COMPARISON OF MINIMUM CRITICAL HEAT FLUX RATIO (MCHFR) WITH NEW AND OLD CORRELATION

EVALUATION

CHANGES TO TECHNICAL SPECIFICATIONS

CHANGE NO. 12

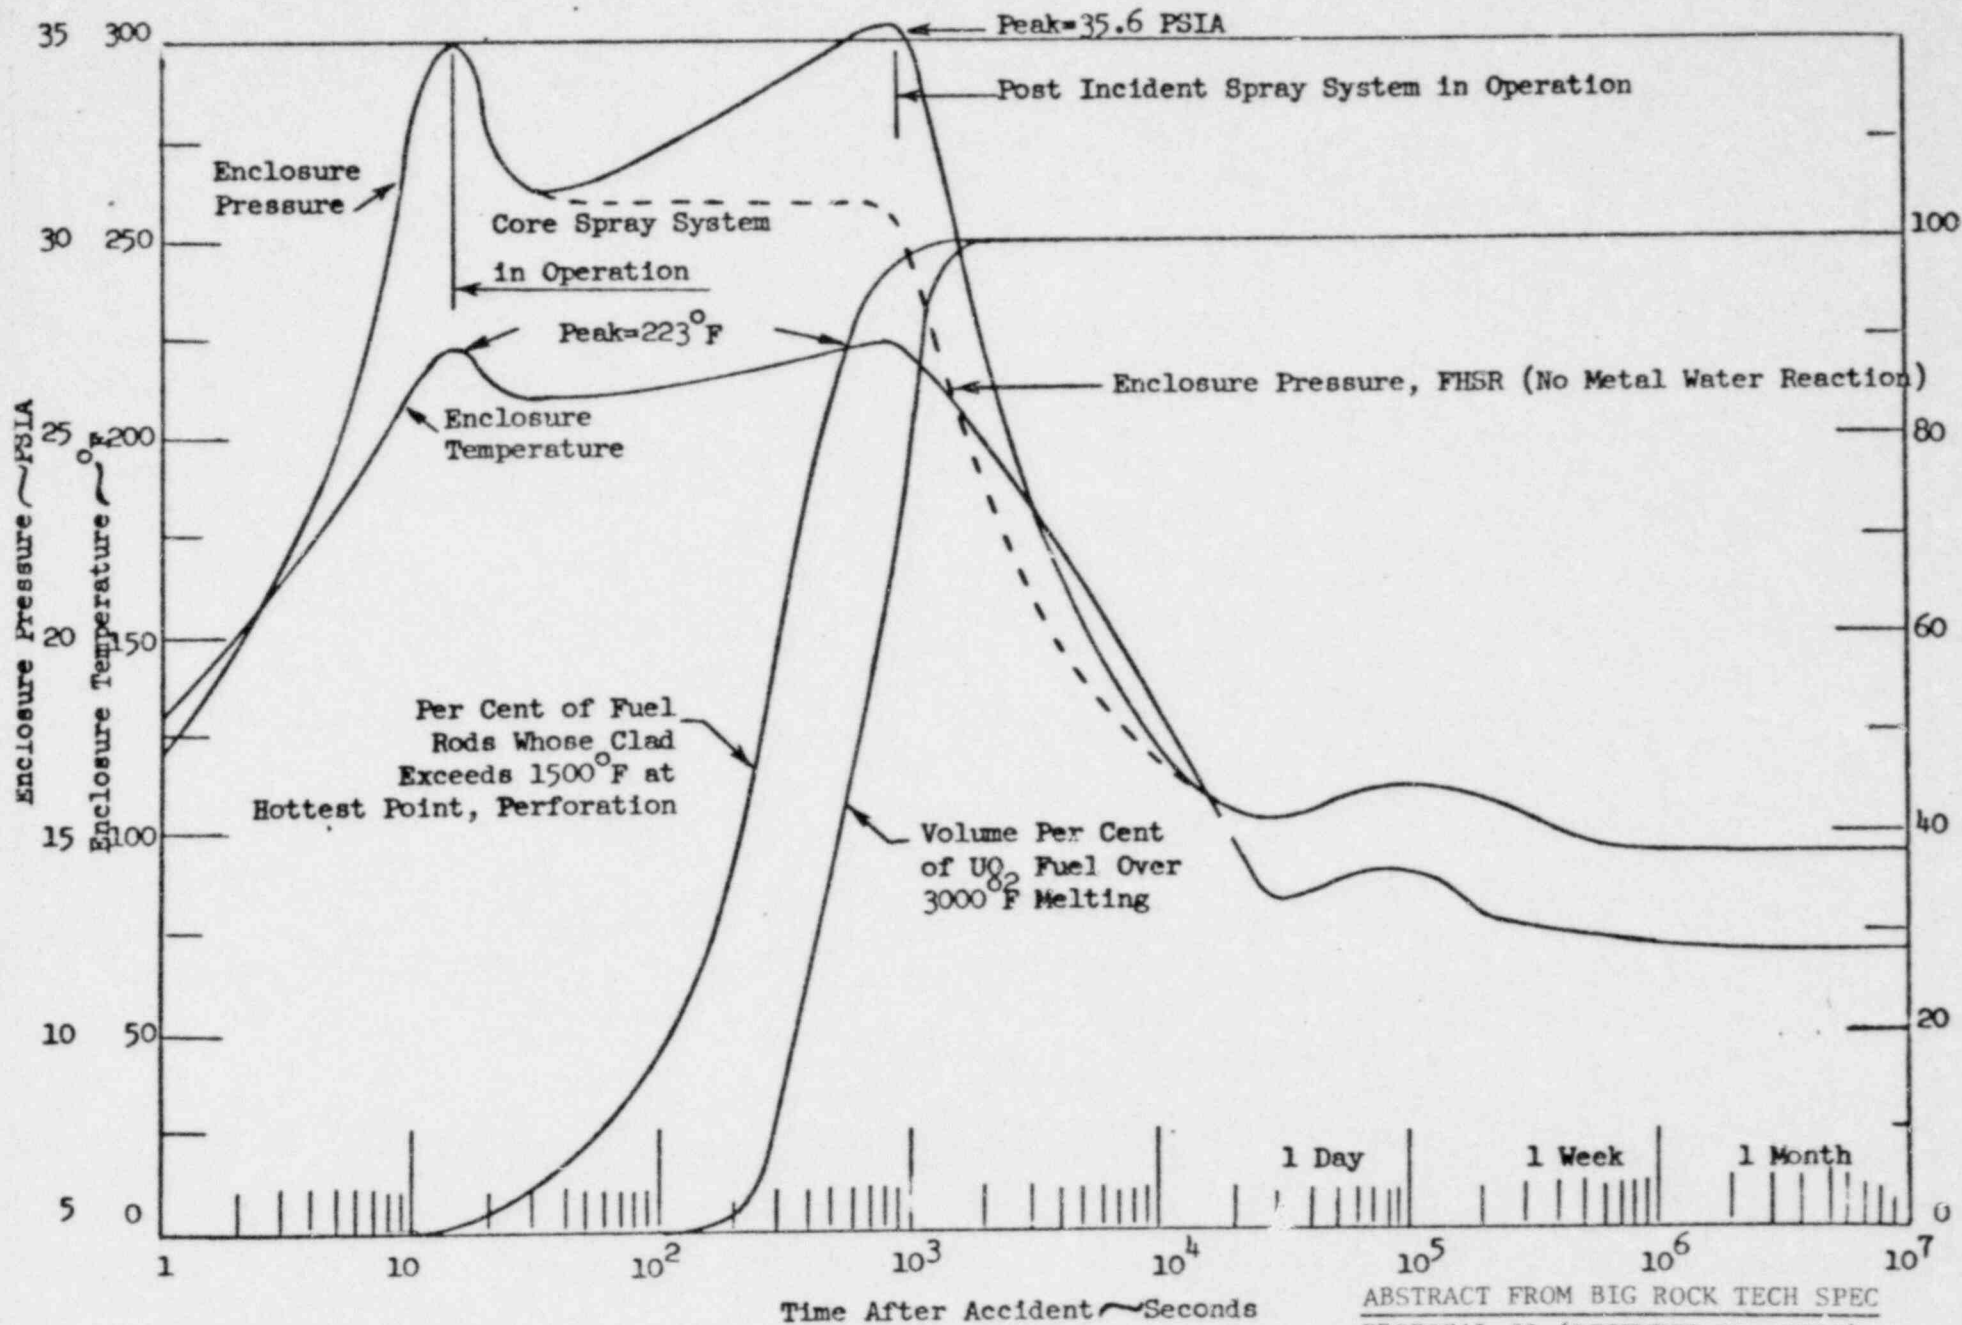
1. Delete the footnote in section 5.2.1(b) and replace with:

"*Based on correlation given in "Design Basis for Critical Heat Flux Condition in Boiling Water Reactors," by J. M. Healzer, J. E. Herch, E. Janssen, and S. Levy, September 1966 (APED 5286 and APED 5286, Part 2)."
